W98-7134 - MAYOR'S EMERGENCY MANAGEMENT OFFICE

Subject: 7 World Trade Center – 23rd Floor
Mayor's Office Of Emergency Management
TAA 987134
Submission #10 - Approval

ATTACHMENT A – LIST OF DRAWINGS
7 WTC – MAYOR'S EMERGENCY MANAGEMENT OFFICE
TAA – 987134
SUBMISSION #10

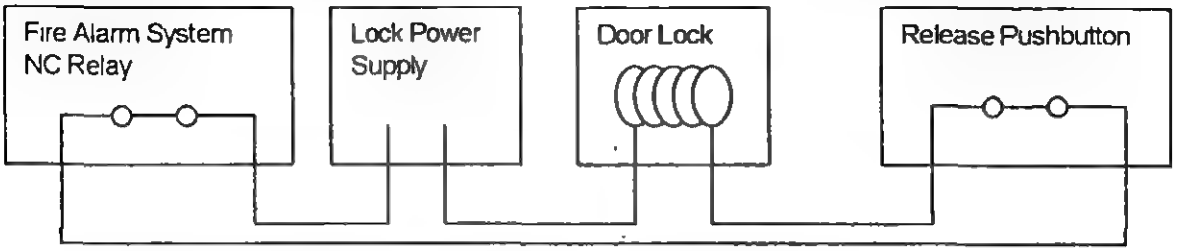
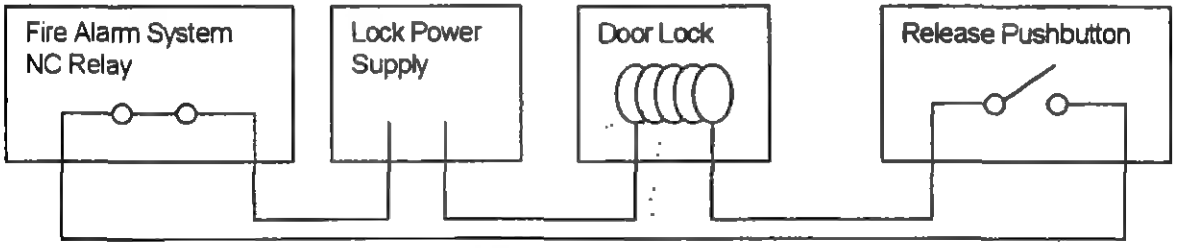
Response: Will comply see-attached drawing. Please note that diagram indicates Typ. Door 40A and 40B are a stand-alone system and are not connected to the secyriry system. Refer to previously approved electrical drawing E1.23 that indicates pull station at the reception area.
